**BERKELEY COUNTY PUBLIC SERVICE SEWER DISTRICT
BERKELEY COUNTY, WEST VIRGINIA**

CONTRACT NO. 7 – TIMBERWALK SANITARY SEWER EXTENSION

ADDENDUM NO. 1

SHEET No.
PS-3

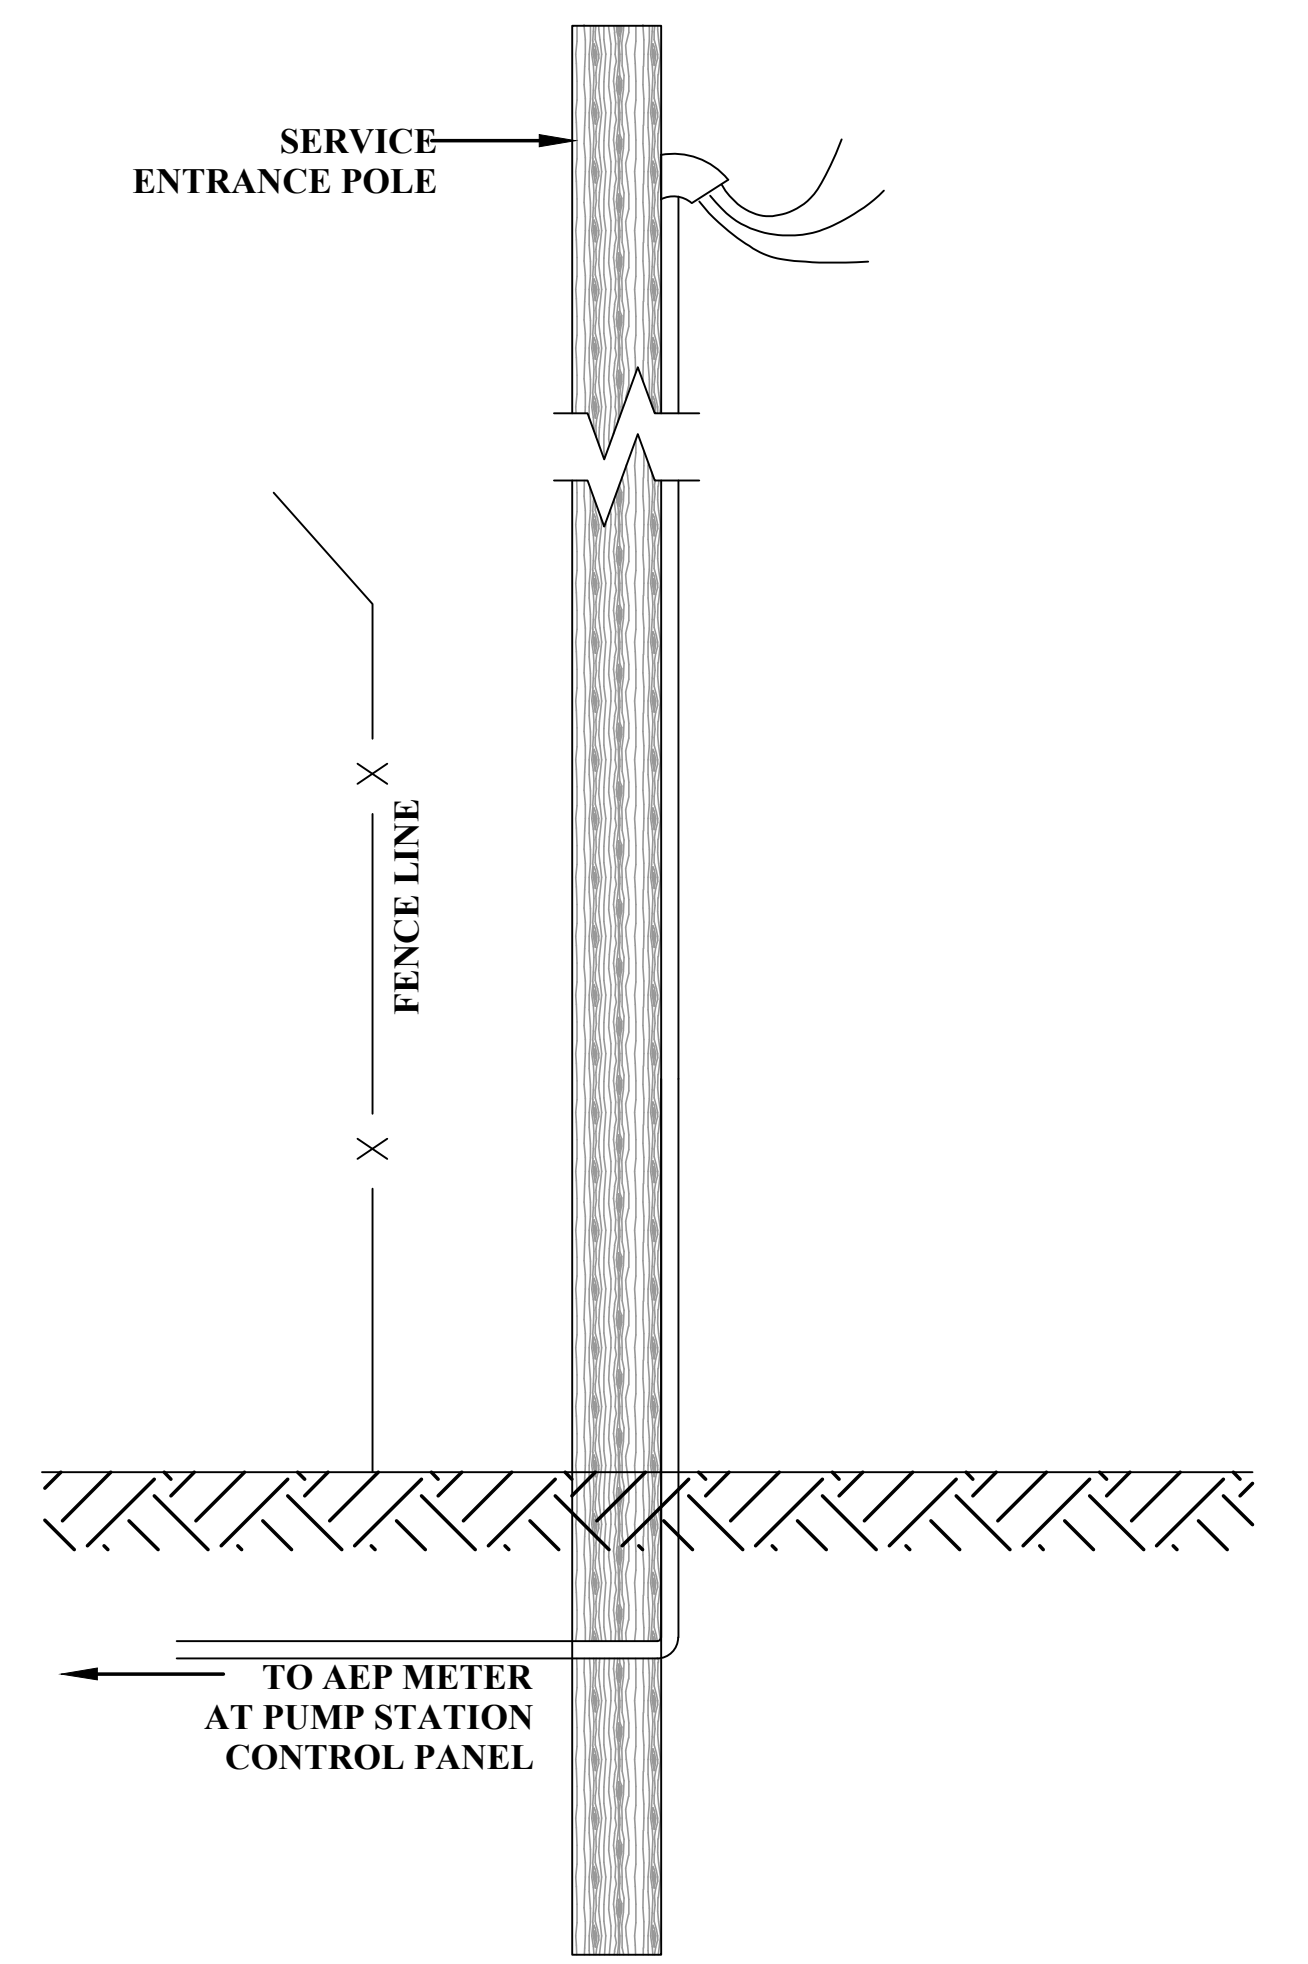
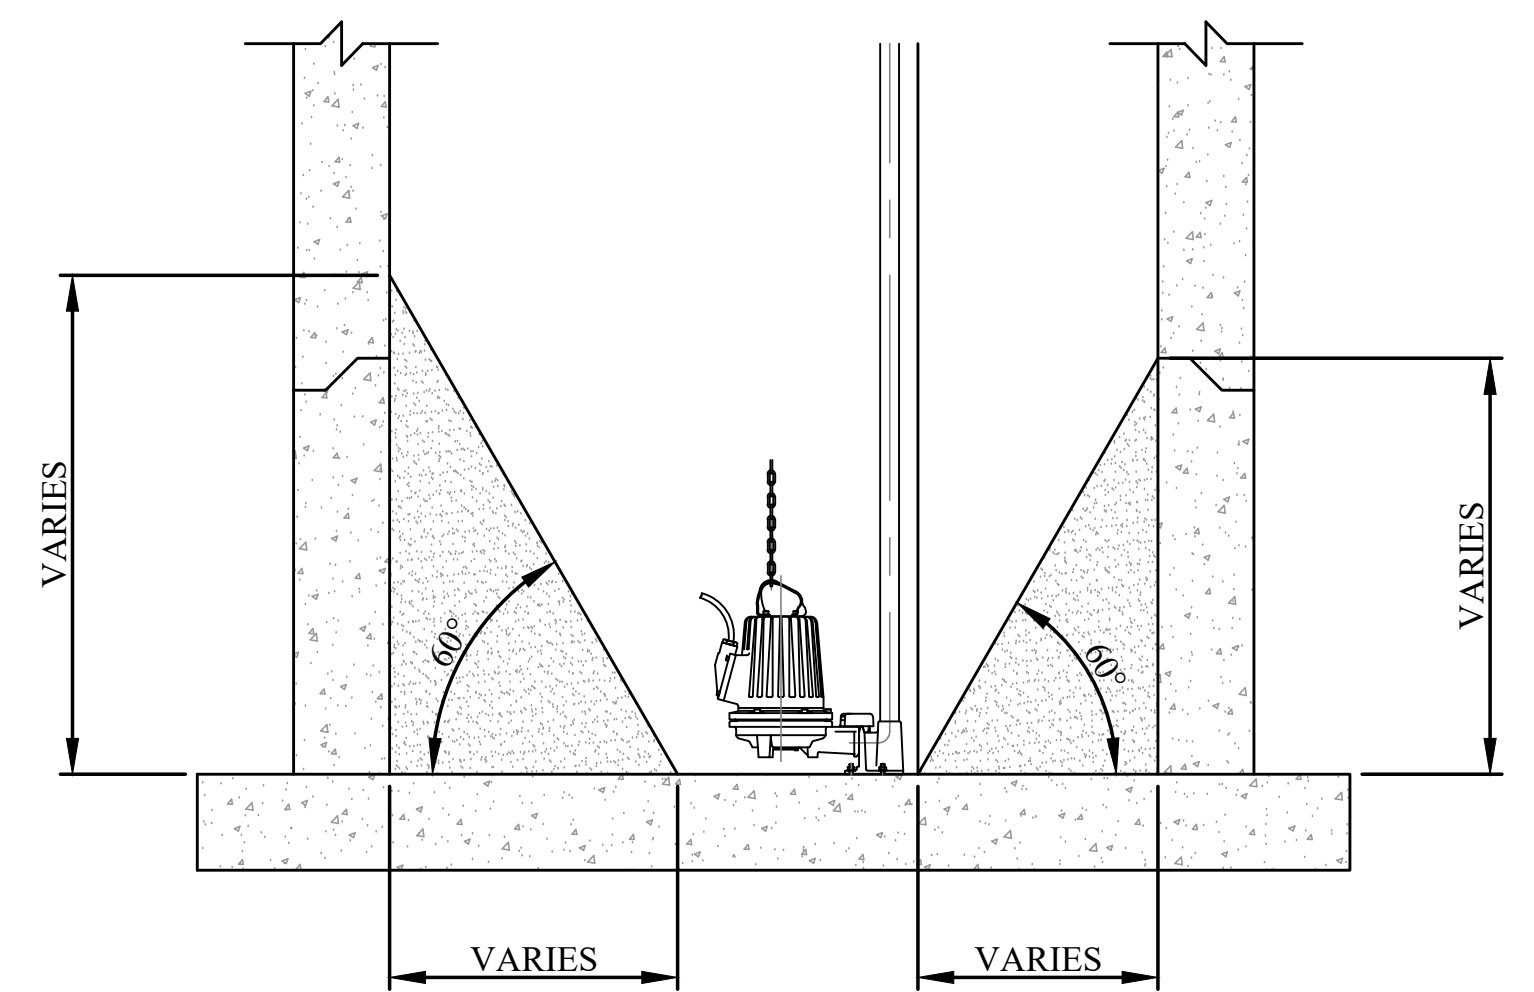
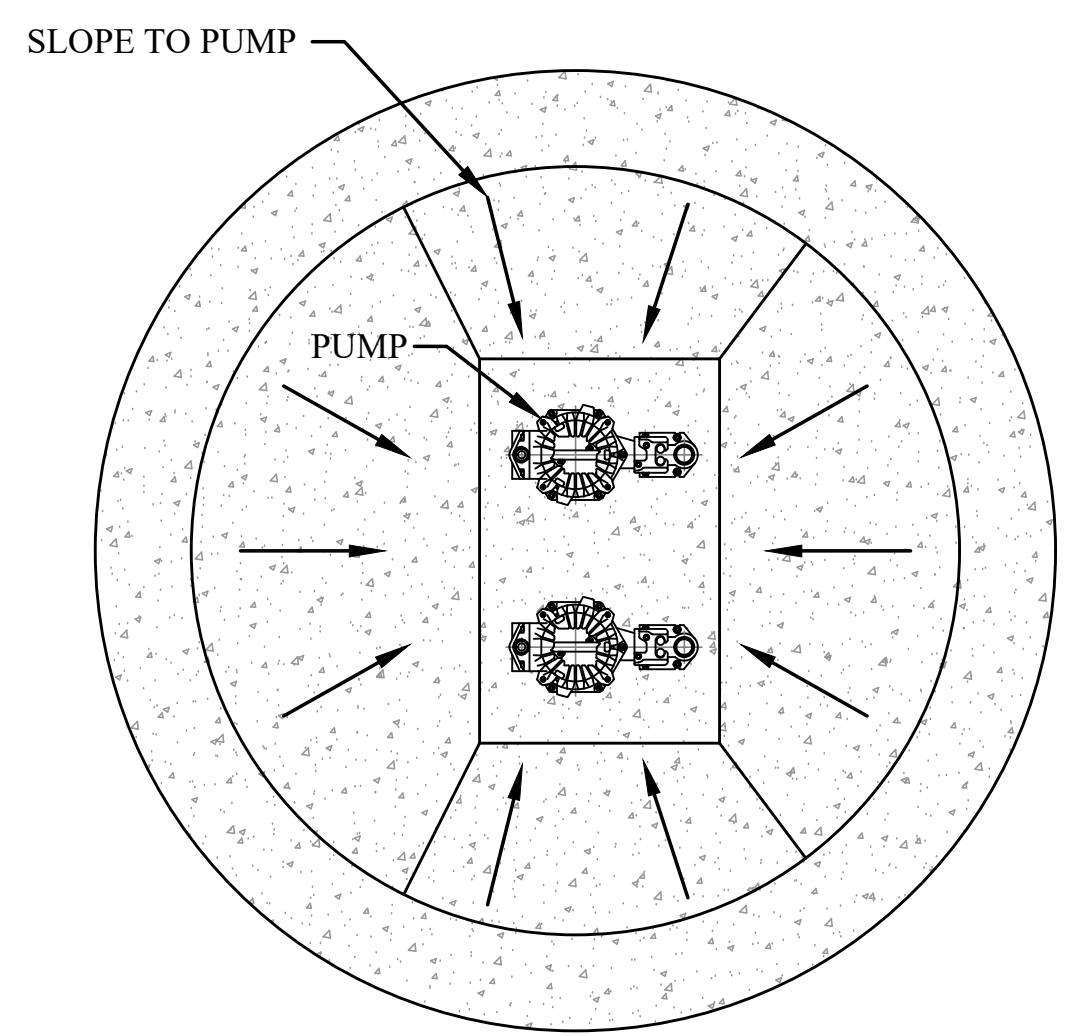
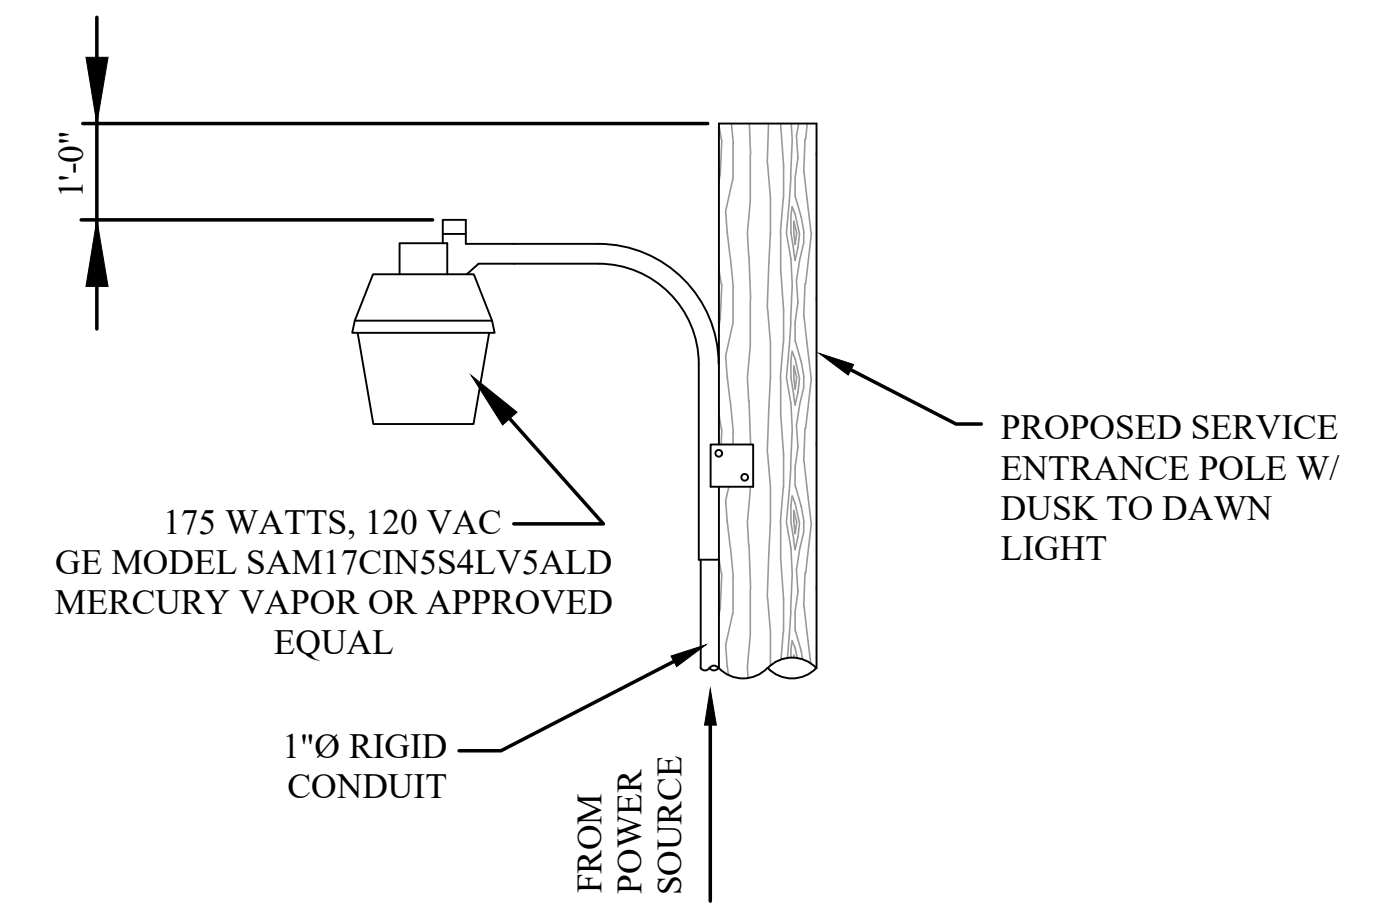
12. **Question:**

Paragraph 2.4.G of Specification Section 333216 – ABOVE GROUND VALVE PACKAGE PUMP STATION WITH SUBMERSIBLE GRINDER PUMPS, in the past, the field crews have stated that they do not want a hoist and socket and that they are piling up at the shop.

Paragraph 2.4.G of Specification Section 333216 – ABOVE GROUND VALVE PACKAGE PUMP STATION WITH SUBMERSIBLE GRINDER PUMPS has been removed. Refer to the revised specification and the revised Sheet PS-3 included with this Addendum No. 1.
